GE Hitachi Nuclear Energy

MFN 09-670

Subject: **Response to a Portion of NRC RAI Letter No. 368 Related to
ESBWR Design Certification Application – Piping Design; RAI
Numbers 3.12-3 S05**

**Response to Portion of NRC Request for
Additional Information Letter No. 368
Related to ESBWR Design Certification Application
- Piping Design
RAI Number 3.12-3 S05¹**

Figure B-3-5(a) Acceleration Time Histories for Vent Wall 701, and RPV Nozzle in N-S Direction from Time 7.5 sec. to 8.0 sec. (Not Correlated)

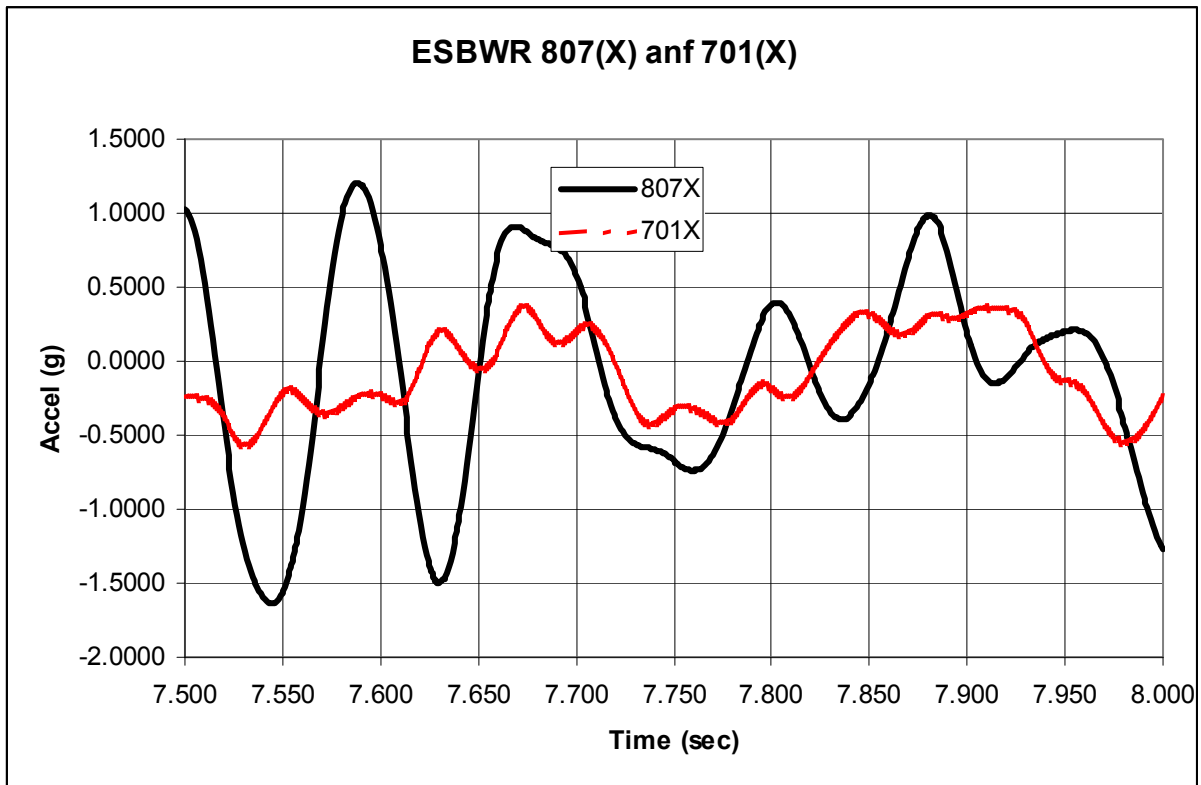
The staff also notes that Figure B-3-5 of the GEH study report, MFN 06-119, Supplement 2, (ML072680480) showed phase correlation in the vertical direction. How does this justify the use of the SRSS method?

Additional time histories plots for the RPV nozzle and vent wall in the horizontal directions, North-South (N-S) and East-West (E-W), are plotted to demonstrate that there will be no correlation in the horizontal direction when the piping is not supported by the same structure. These plots are presented with this RAI response: It is noted that the time period selected for the plots is between 7.5

Figure B-3-5 (a) - Acceleration Time Histories for Vent Wall 701, and RPV Nozzle in N-S Direction from Time 7.5 sec. to 8.0 sec. (Not Correlated)

The above four figures illustrate that in the horizontal direction the N-S and E-W time histories at the RPV nozzle and the vent wall are not correlated. Additional plots for Nodes 206 and 807 in the horizontal direction are also provided for reference. The necessary conditions to have correlated time histories are:

Since the vertical direction for the cases evaluated in the study met these conditions, the comparison plots show that phase correlation was present, but since the other two directions were not correlated, the results of the study still demonstrates that the SRSS method was valid when the 10% adder was applied.
